FINAL PRODUCT/PROCESS CHANGE NOTIFICATION #16793Generic Copy

Issue Date: 27-Jan-2012

TITLE: Addition of OSPI manufacturing site for automotive grade Serial EEPROM products in SOIC 8-pin package.

Example:

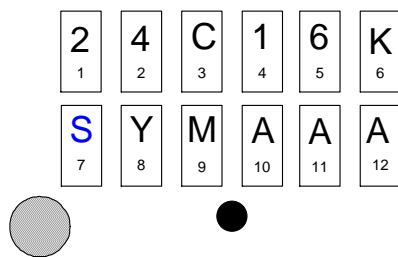
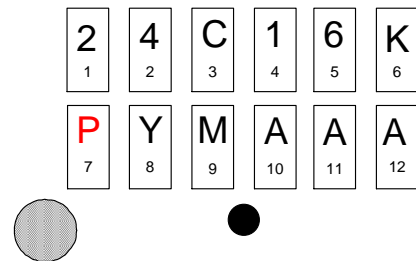
The OSPI manufacturing site is identified by letter “P” for the “Assembly Location Code”: first character, 2nd line of the top package marking.

CAV24C16WE-GT3 at STARS

CAV24C16WE-GT3 at OSPI
